AGENDA OF THE LANDMARKS COMMISSION

WEDNESDAY, FEBRUARY 19, 2025, 4:30 PM
City Hall, Room 604 - The Harry Maier Room.
Virtual attendance is also available via Zoom.

Report to the
Landmarks Commission
of the City of Green Bay

(COA 25-01) Consideration with possible action on a design review for a cell tower at 1424 Admiral Court.

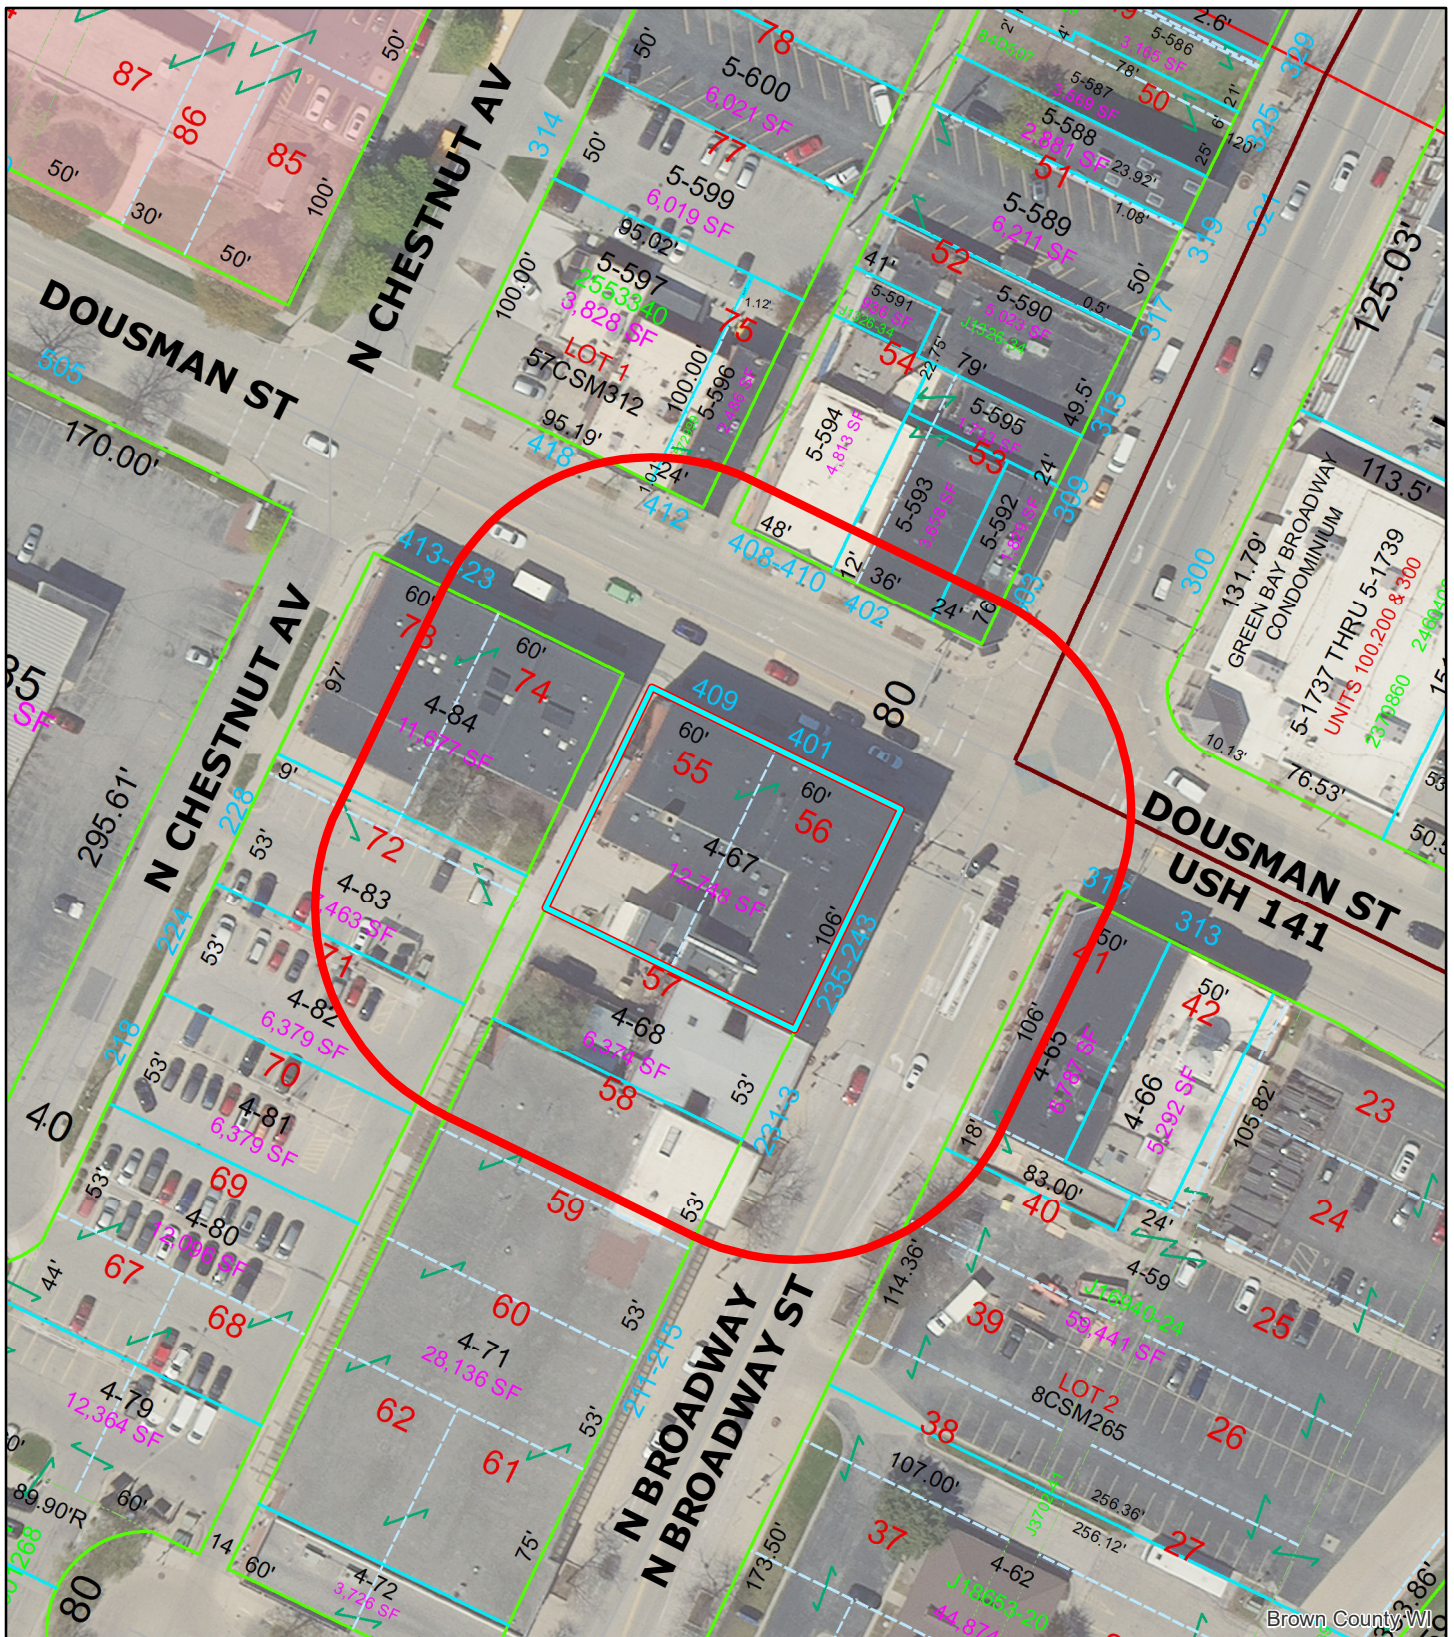
Cornice - The cornice material to be removed is not likely historic material, and the proposed replacement material closely matches that currently present. The current material consists of 4" wide boards. The replacement material will be 6" wide. Given the height and painted nature of the existing and replacement material, this change in width is not likely to be noticeable and is not going to have a significant impact on the historic integrity of the building or district. No information has been provided that details the original materials used on the cornice.

Pilasters - The textured concrete pilasters are currently painted. Painting of previously painted surfaces in good condition does not require LC approval.

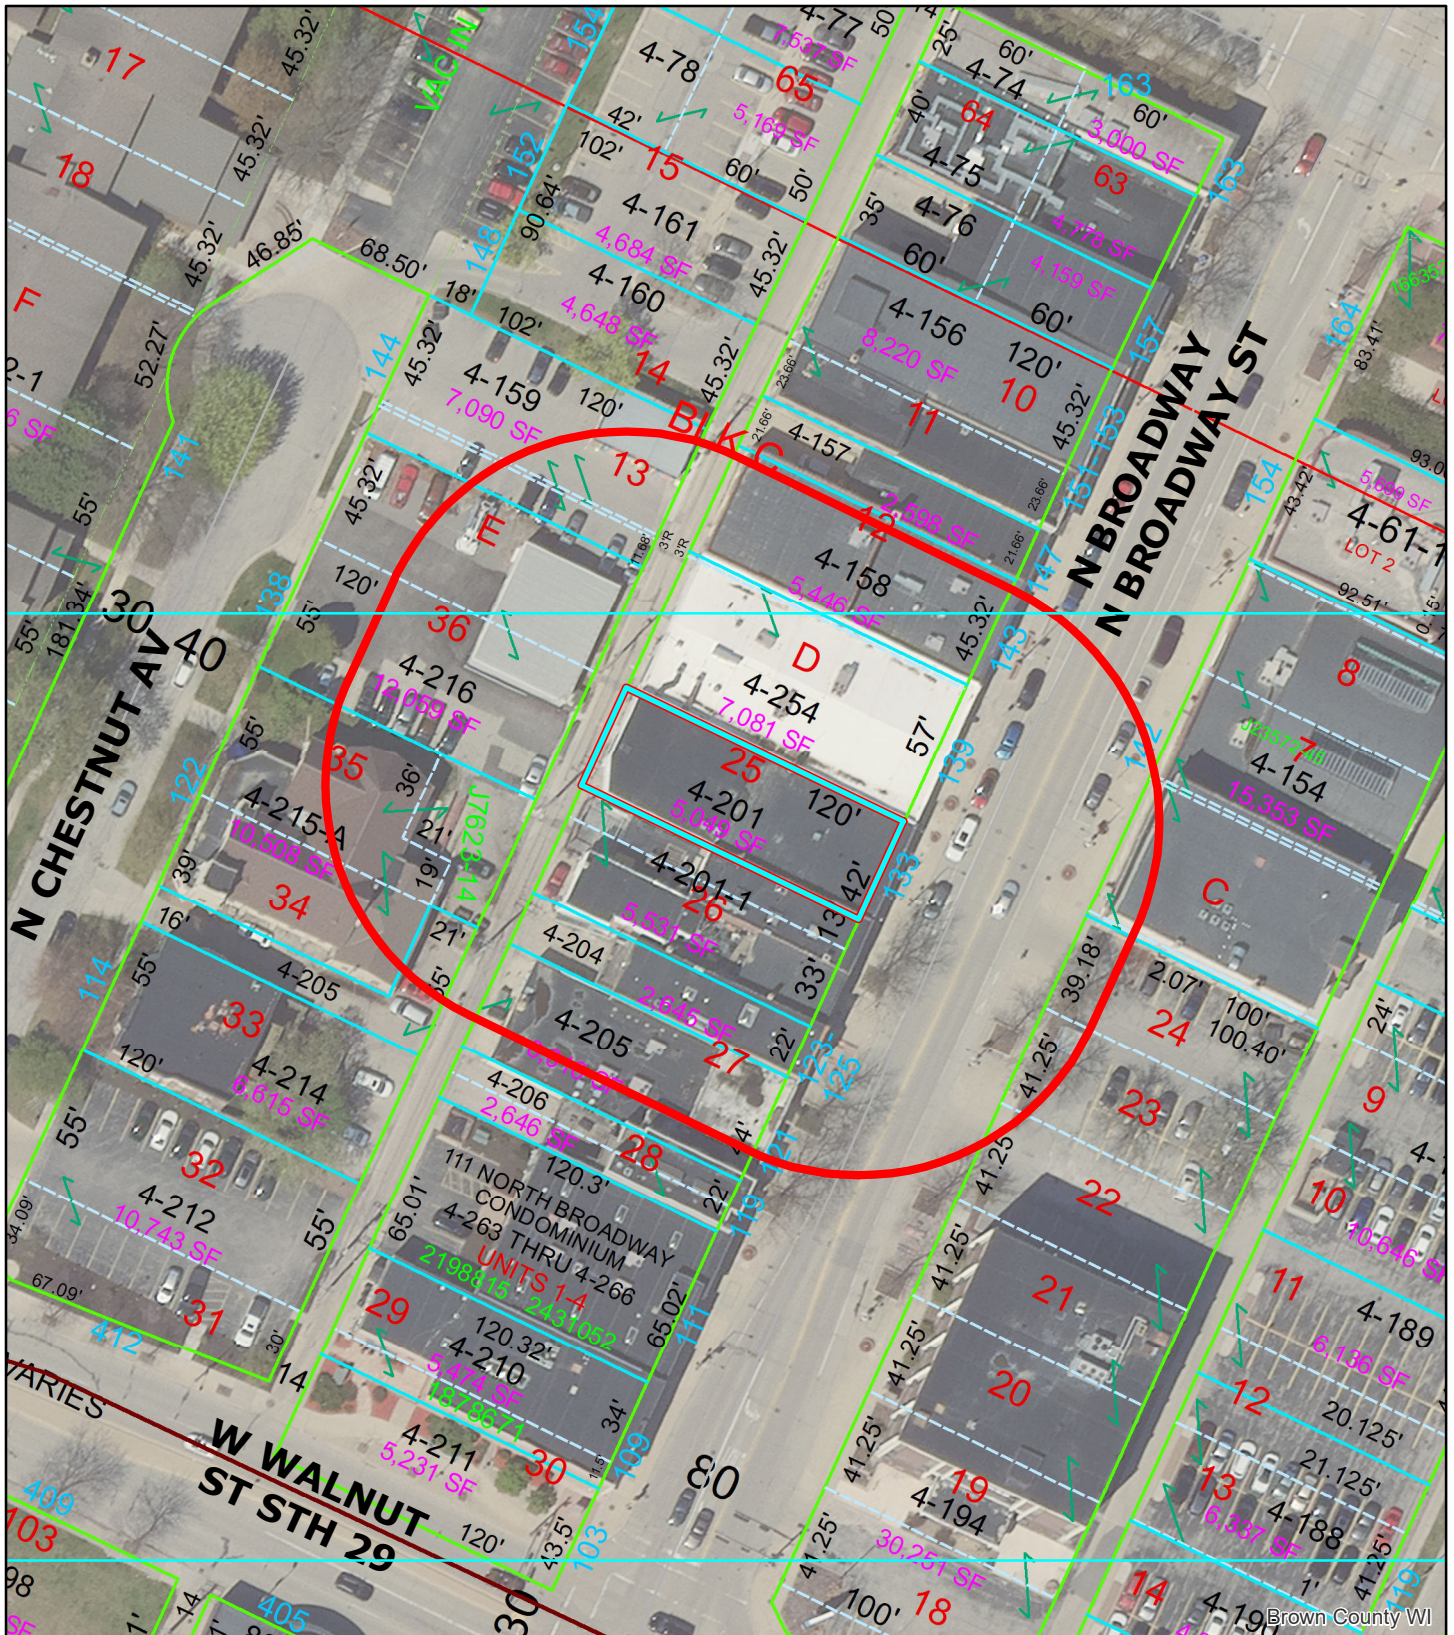
Storefront – The existing storefront matches that present at time of NRHP listing in 1999 and that shown in a 1986 photograph – a symmetric façade with recessed doorway at center. No historical images have been provided (ref. SOI # 6). The proposed alteration calls for a new recessed entrance to be added north of the existing doorway. This new recessed entrance, as proposed, does not appear to have a comparable precedent on this building and will have a significant impact on the appearance of the building (ref. SOI # 2) and does not mimic the design of secondary entrances elsewhere in the district (the surrounding streetscape). Alternative designs appear to be possible that could eliminate or minimize the visual impact of introducing a second door on the storefront.

Windows & doors – The proposed window specifications do not appear to include window frame finish details (anodized vs. painted vs. other?). Similarly, there is no information provided for the new, second, front door. Per Wisconsin SHPO, “Anodized finishes are not appropriate”. (<https://www.wisconsinhistory.org/Records/Article/CS4141>).

LC staff recommends careful consideration of the proposed storefront design, noting that the proposed design does not appear to satisfy the requirements of the SOI or Preservation Brief II and noting that design alternatives may be available.

LC staff notes that the proposed changes to the rear elevation will have a minimal impact to the historic integrity of the building and the district. LC staff notes that window and door frames should have a painted or powder coat finish (not anodized).
